AMENDMENT OF SOLICITATION/MODIFICATION OF CONTRACT				1. CONTRACT ID CODE J		PAGE OF PAGES 1 2	
2. AMENDMENT/MODIFICATION NO. 0005		3. EFFECTIVE DATE 12-Jul-2004		4. REQUISITION/PURCHASE REQ. NO. W81D4A-4020-1314		5. PROJECT NO.(If applicable)

14. DESCRIPTION OF AMENDMENT/MODIFICATION (Organized by UCF section headings, including solicitation/contract subject matter where feasible.) The purpose of this amendment is to provide answers to submitted questions. See attached list of Questions and Answers. The date and time for receipt of proposals is not extended or changed. While the date for receipt of offeror questions has passed, we will continue to accept questions. Further questions, however, may or may not be answered by another amendment. Proposals should be prepared based upon information in the Request for Proposals, as amended.							
Except as provided herein, all terms and conditions of the document referenced in Item 9A or 10A, as heretofore changed, remains unchanged and in full force and effect.							
15A. NAME AND TITLE OF SIGNER (Type or print)				16A. NAME AND TITLE OF CONTRACTING OFFICER (Type or print)			
				TEL: _____ EMAIL: _____

Answers to Questions

VACUUM PRIMING SYSTEM DOGHOUSE MANHOLE DETAIL
N.T.S.

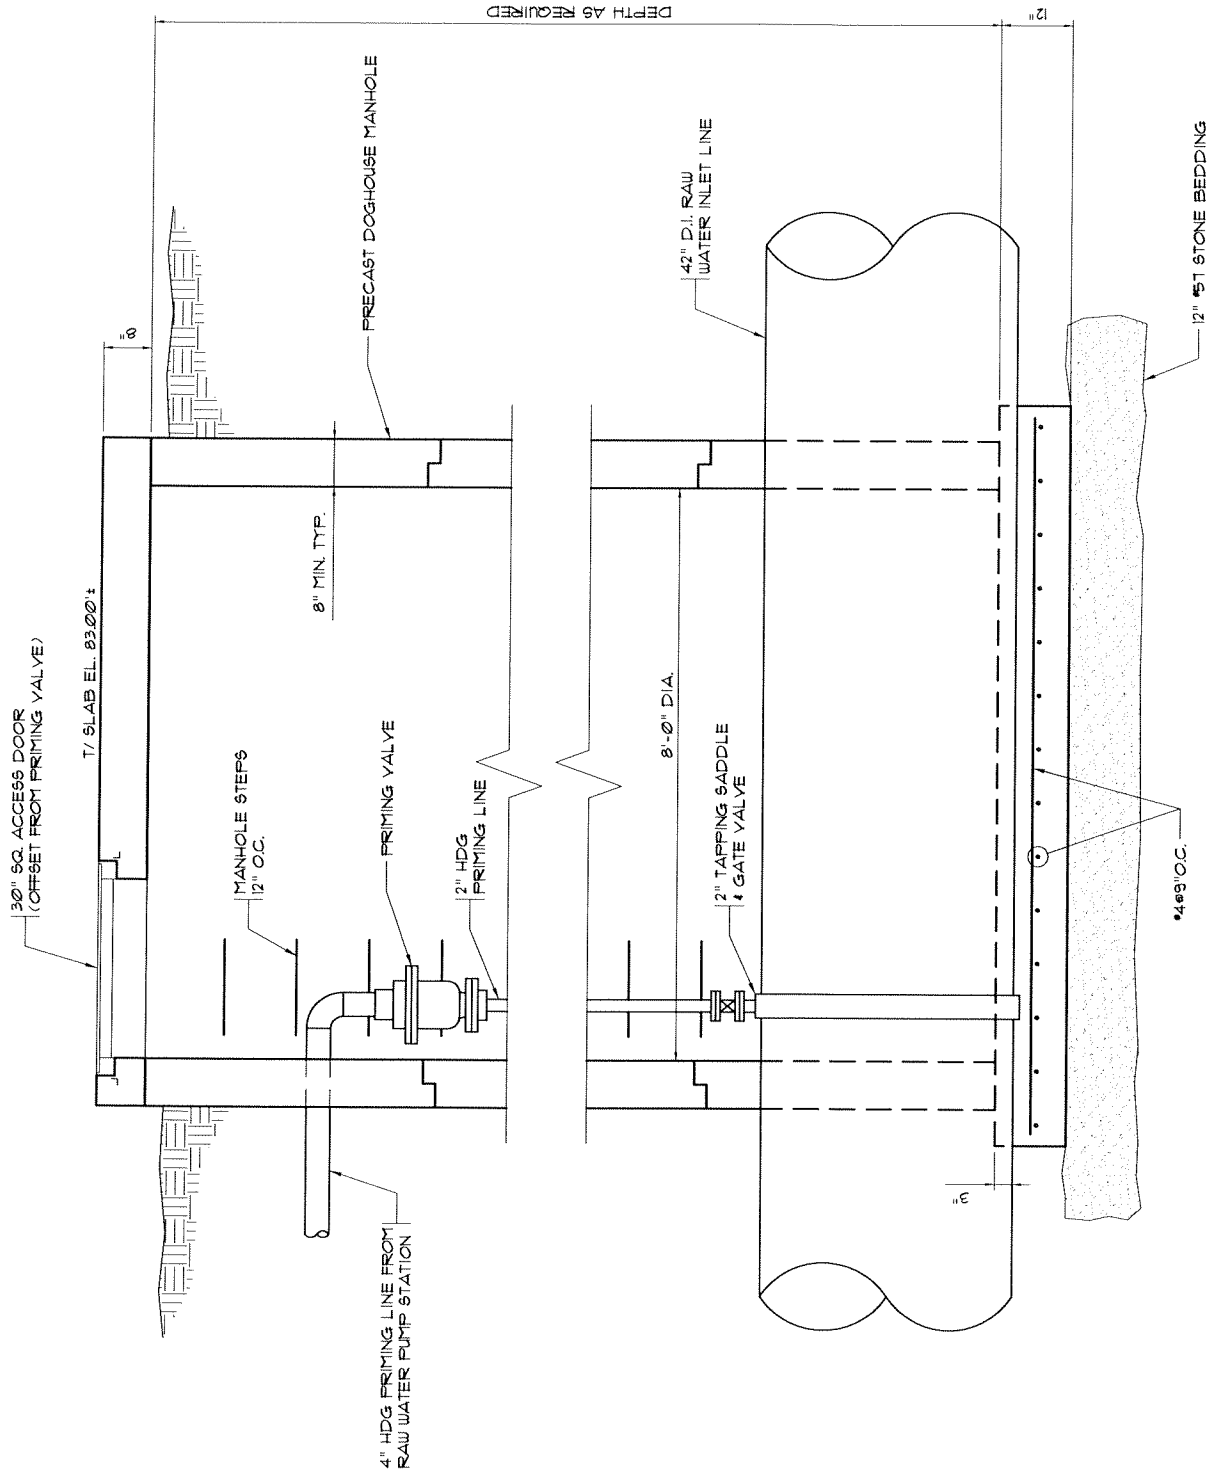
1. Is a detail available for the 8' ODA Vacuum Manhole on the Raw Water Intake? If yes, please provide.

Answer: A detail of the 8' doghouse manhole is provided in .pdf format.
